# Access Compliance Report

## Public Rights-of-Way

Intersection ID: 25211	Main Street: SMITH_RD	Cross Street: SOUTHBRIDGE_FOREST_DR	Location: SE
ADA ID: ADAB08BA14C1	Ramp Type: Perp	Initial Pass/Fail: Fail	Overall Compliance: No
Severity Score: 13.75			
Codes/Mitigation Info/Possible Solution		Field Measurements/Component Compliance

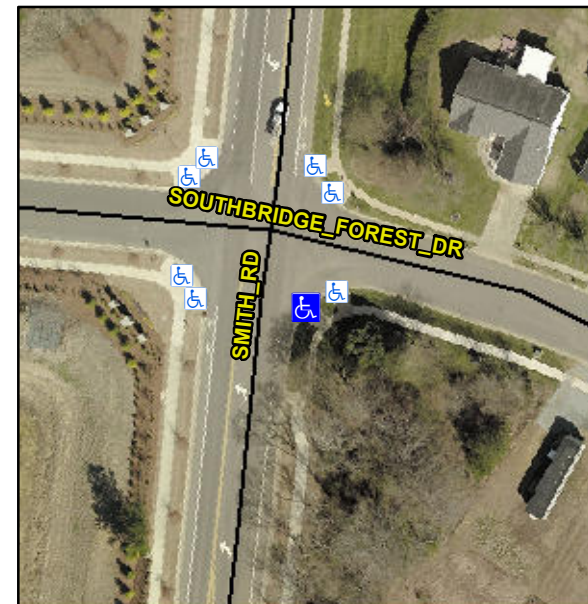
**Remove & Replace Entire Ramp.**

**Not Found, R304.2.2, R304.5.3**
